Mobile Intel[®] Pentium[®] II Processor Specification Update

Release Date: December 2002

Order Number: 243887-047

New Mobile Pentium® II Processor in Mini-Cartridge Package Label with Supplier Matrix Mark Removed

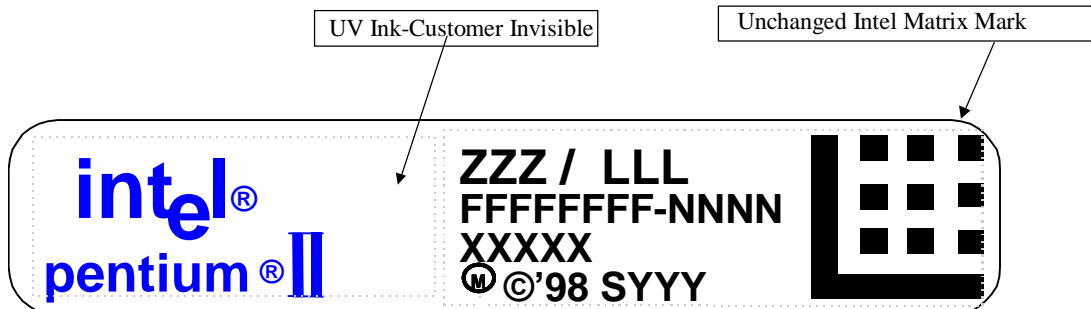
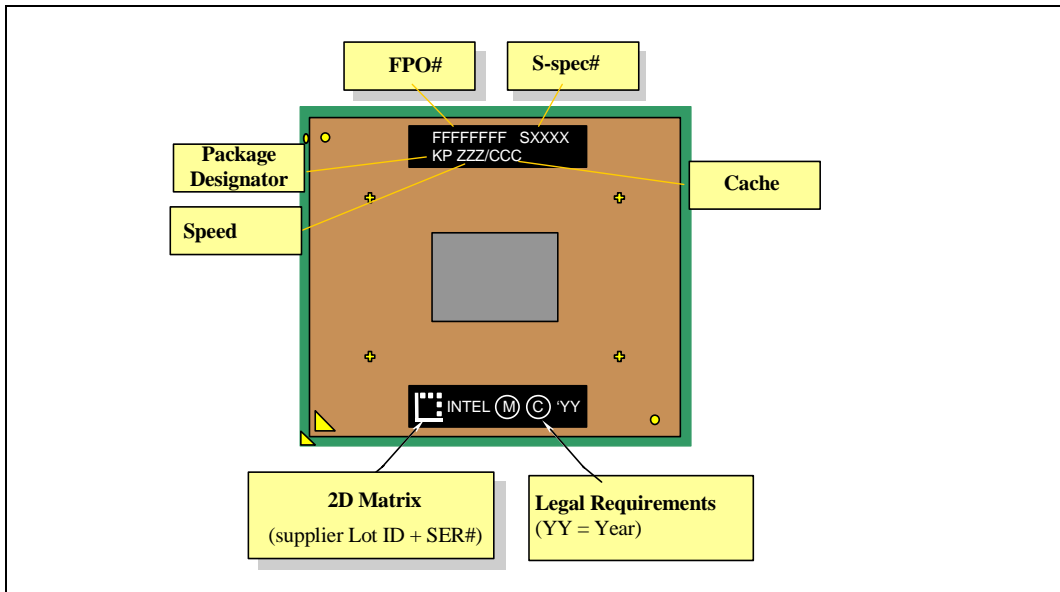
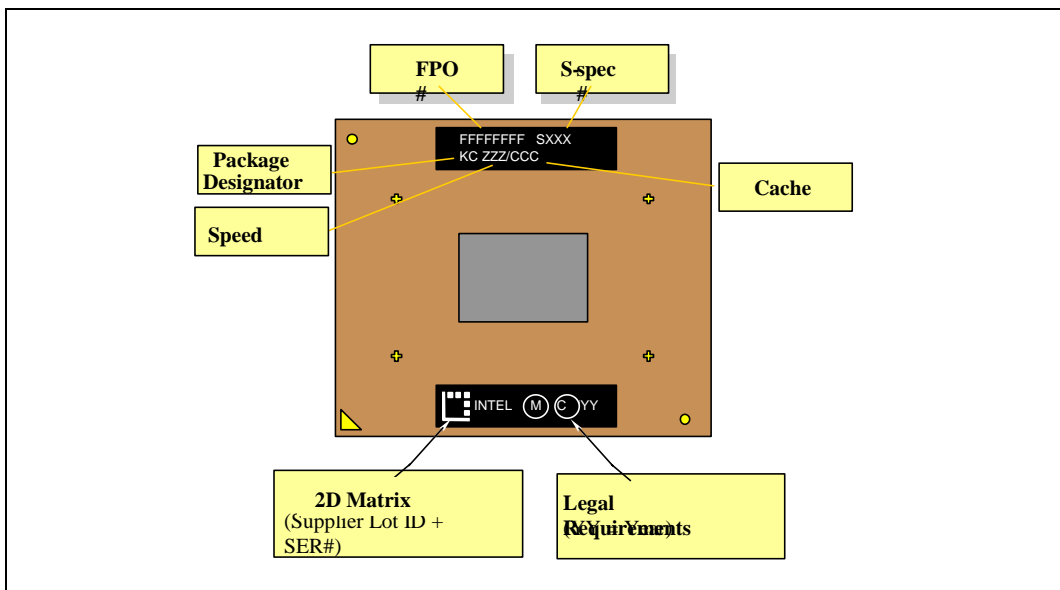
Old Mobile Pentium® II Processor in Mini-Cartridge Package Label with Supplier Matrix Mark

Figure 1. TAP Gageable Thread Clarification

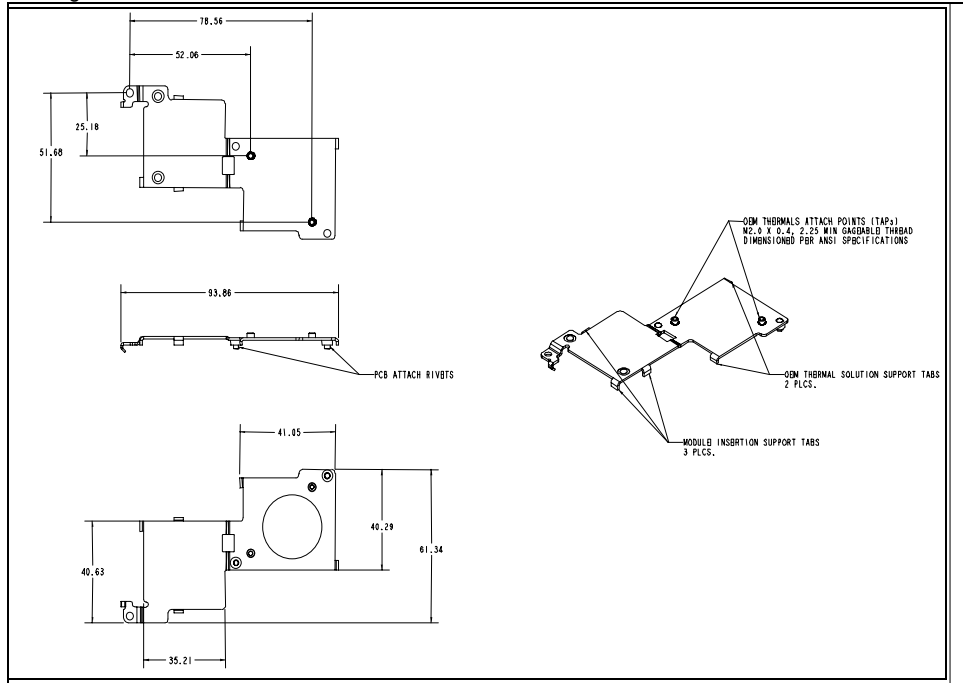
In the *Intel® Pentium® II Processor Mobile Module : Mobile Module Connector 1 (MMC-1)* and the *Intel® Pentium® II Processor Mobile Module : Mobile Module Connector 2 (MMC-2)* datasheets (Order Numbers 243667 and 243668, respectively), the thermal attach point (TAP) gageable thread specification was not clearly identified in Figure 14, of Section 5.2. The following is the TAP clarification:

OEM Thermal Attach Points (TAPs) M2.0 x 0.4, 2.25 min gageable thread dimensioned per ANSI specification.

See Figure 1 below for more information.
